NORTHCREST CENTER DEVELOPMENT PLAN

2510 & 2522 CANADA DR
COLORADO SPRINGS, COLORADO 80922

PCD FILE NO PPR-21-036

DEVELOPMENT PLAN
-COVER SHEET
DEVELOPMENT PLANS

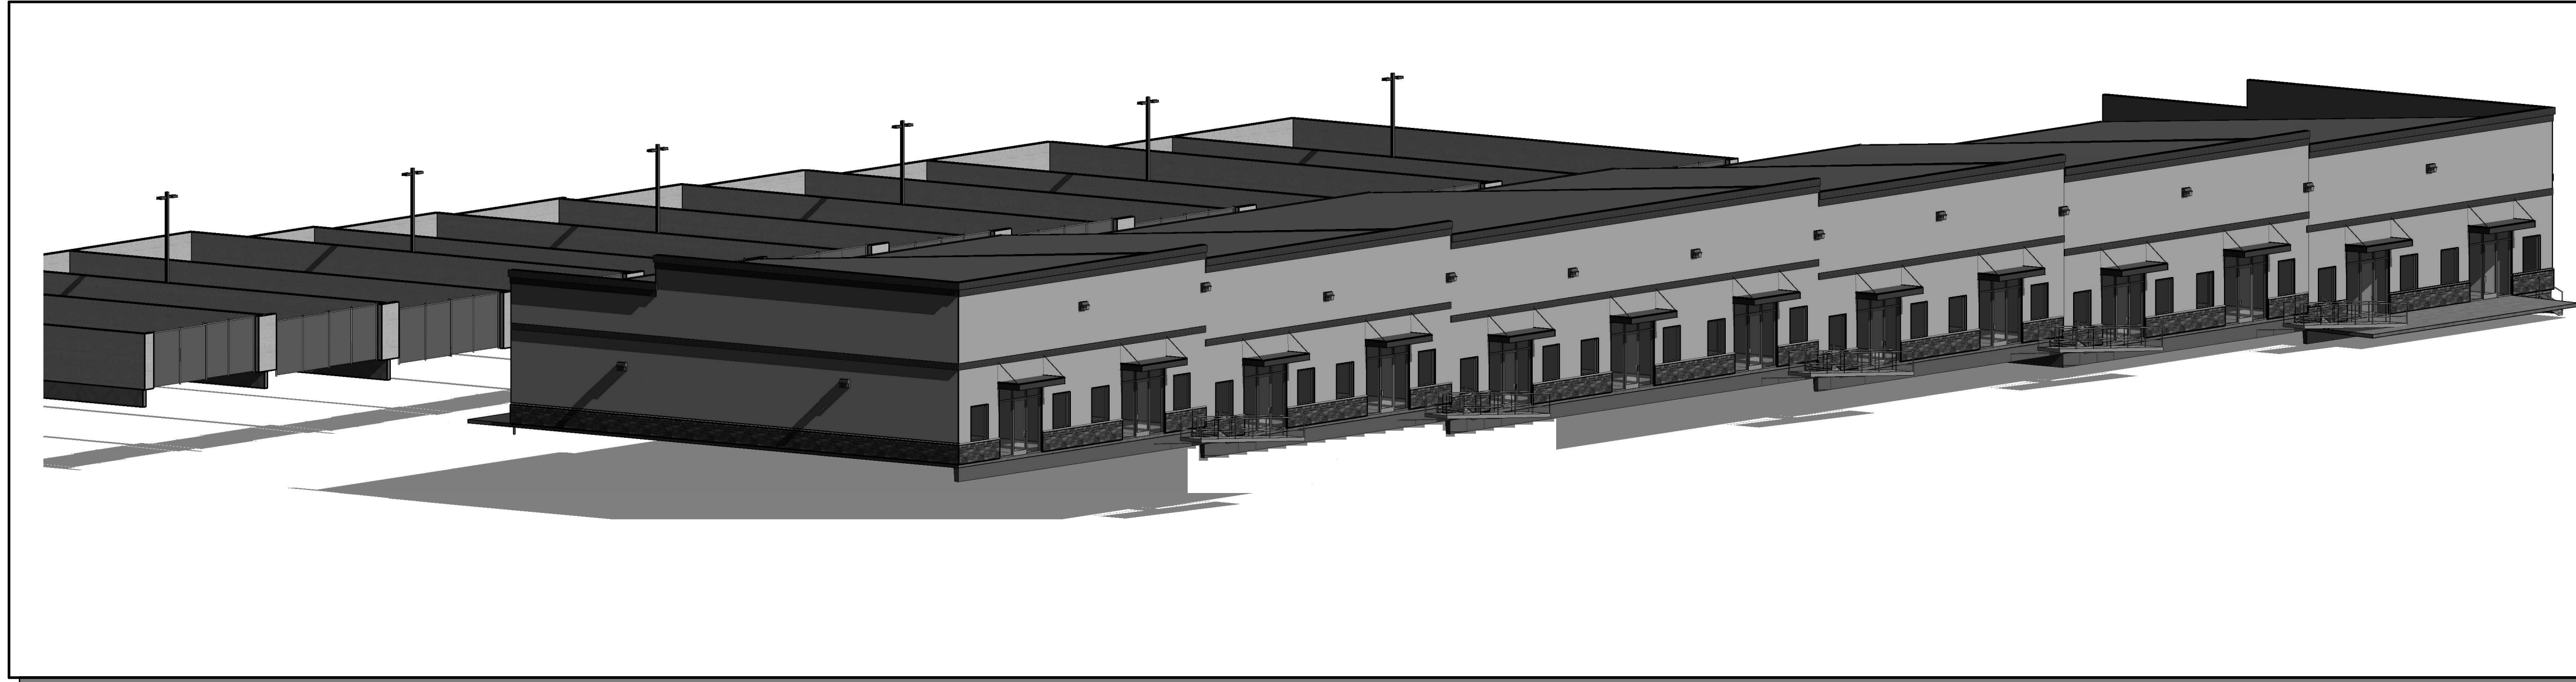
Please update Site Development Plan to reflect changes made to other plans.
